**Economic and Social Council**Distr.: General
17 December 2020

Economic Commission for Europe**Inland Transport Committee****World Forum for Harmonization of Vehicle Regulations****183rd session**

1958 Agreement:**Consideration of draft amendments to existing****UN Regulations submitted by GRBP****Proposal for Supplement 19 to the original series of amendments to UN Regulation No. 75 (Tyres for L-category vehicles)****Submitted by the Working Party on Noise and Tyres***

Annex 2, amend to read:

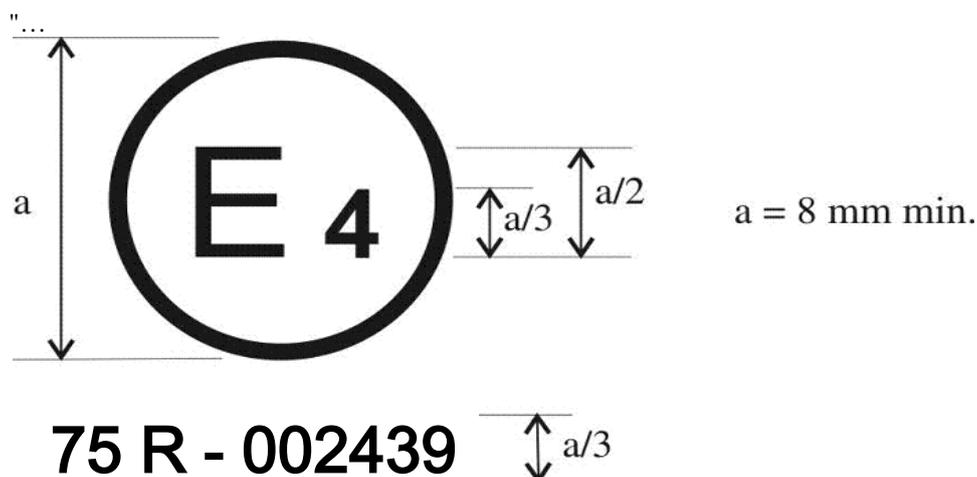
The above approval mark affixed to a tyre shows that the type of tyre concerned has been approved in the Netherlands (E 4) pursuant to UN Regulation No. 75 under approval number 002439. The first two digits of the approval number indicate that the approval was granted in accordance with the requirements of UN Regulation No. 75 in its original form.
